**RF-11  
Salado Draw Section  
23 Recycling Facility  
and Containment-  
Facility ID  
[fTO1706148730]  
Annual Extension  
Approved**

**[4323] CHEVRON USA INC  
November 30, 2022**

**C-147 Extension request (Salado Draw NM 1RF-11)**

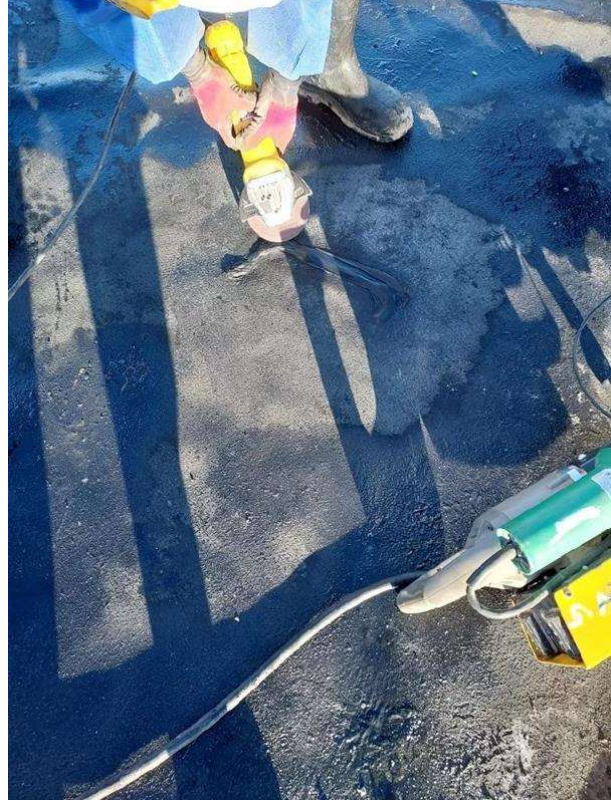
The annual extension request includes weekly inspection records showing that the pond was drained to repair the liner. We don't have any notification of that, nor did we receive an extension request to repair the liner

Per 19.15.34.13.B(4) and (5):

(4) If the containment's primary liner is compromised above the fluid's surface, the operator shall repair the damage or initiate replacement of the primary liner within 48 hours of discovery or seek an extension of time from the division district office.

(5) If the primary liner is compromised below the fluid's surface, the operator shall remove all fluid above the damage or leak within 48 hours of discovery, notify the division district office and repair the damage or replace the primary liner

Could you please clarify the status of the liner?

The liner was repaired on 10/25/22. However, the sump area had accumulated water, so they drained the water and found 2 small leaks. Water team drained sump and repaired both liner leaks on 11/14/22 and added 3-4 ft of water to verify. No issues of liner leaks resulted after this repair. We have attached the pictures that verify all 3 liner repairs.

1RF-11: The liner was repaired on 10/25/22. However, the sump area had accumulated water, so they drained the water and found 2 small leaks. Water team drained sump and repaired both liner leaks on 11/14/22 and added 3-4 ft of water to verify. No issues of liner leaks resulted after this repair. We have attached the pictures that verify all 3 liner repairs.
